SUBDIVISION REPORT - CONCEPT/DEVELOPMENT PLAN

► **FILE #:** 11-SA-22-C (REVISED) **AGENDA ITEM #:** 30

► **SUBDIVISION:** FAIRVIEW ROAD SUBDIVISION

► **APPLICANT/DEVELOPER:** MESANA INVESTMENTS, LLC

SHEET C-1

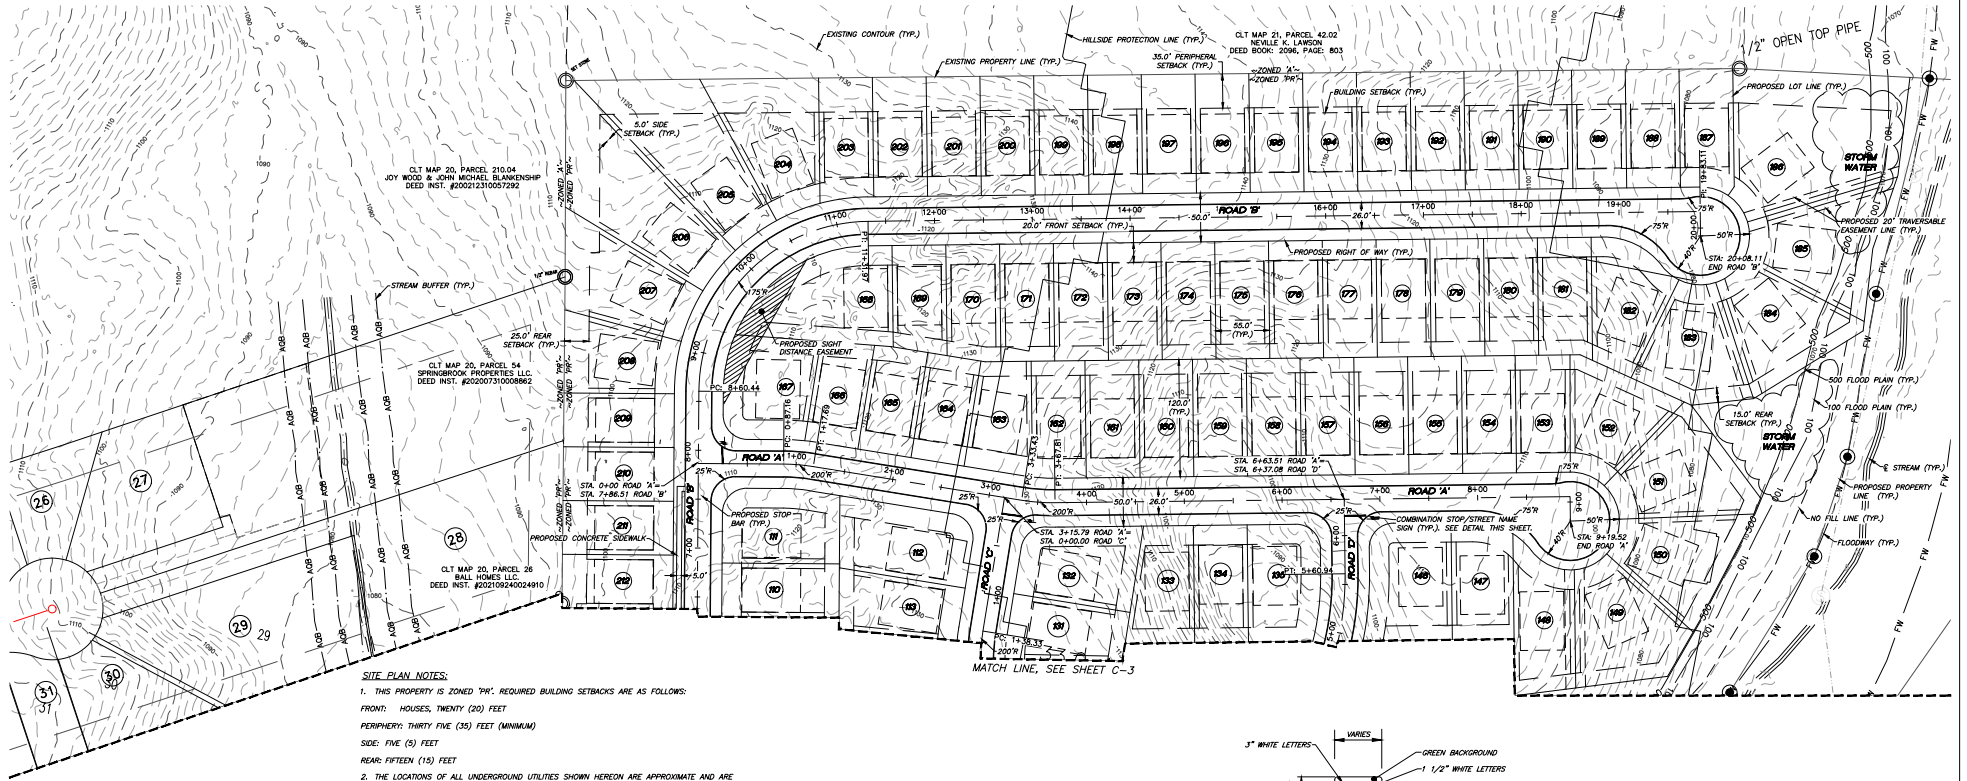
- **Approve the requested variances and alternative design standard based on the justification provided by the applicant and recommendations of the Knox County Department of Engineering and Public Works.**

Approve the Concept Plan subject to 11 conditions.

- 3) Providing a sight distance easement across the lots on the inside of the horizontal curves with a radius less than 200 ft per the requirements of Knox County Engineering and Public Works during the design plan phase. Any driveways on these lots must be located outside the sight distance easement and shown on the plat, or the driveways must have a depth of 20 ft beyond the sight distance easement if they cannot be located outside the sight distance easement.

- 5) Obtaining all necessary permits from TDOT for the improvements at the Beeler Road and E. Emory Road intersection.
- 6) Providing a 50-ft wide right-of-way stub-out from Road 'B' to the property to the north (parcel 021 04202). The stub-out shall be provided on the Final Plat and identified for future connection. The location of the stub-out shall be reviewed and approved by Knox County Engineering and Public Works during the design plan phase.

SHEET C-4

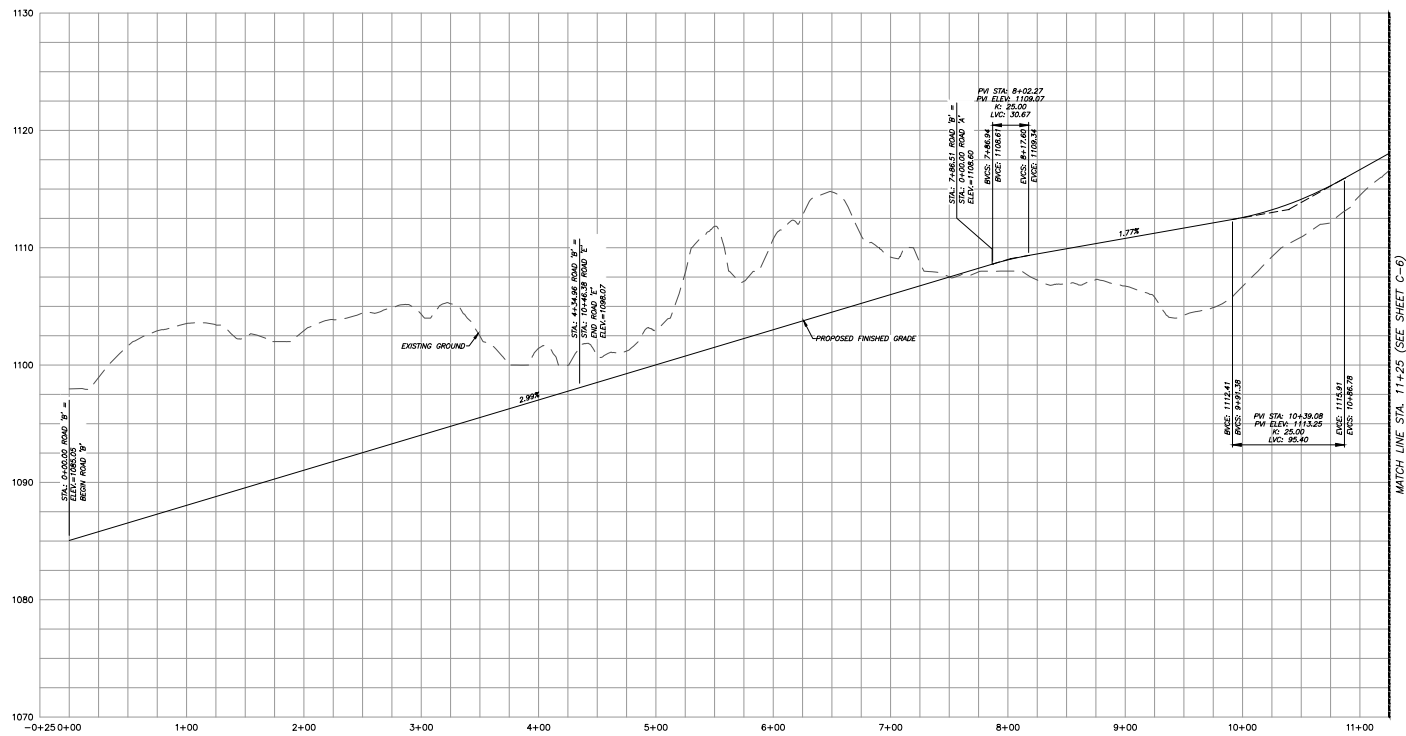
- VARIANCES**
1. Reduce the minimum vertical curve tangent K value from K=25 to K=18.5 at STA 1+57.63, Road D
 2. Reduce the minimum vertical curve tangent K value from K=25 to K=22.5 at STA 3+14.59, Road A
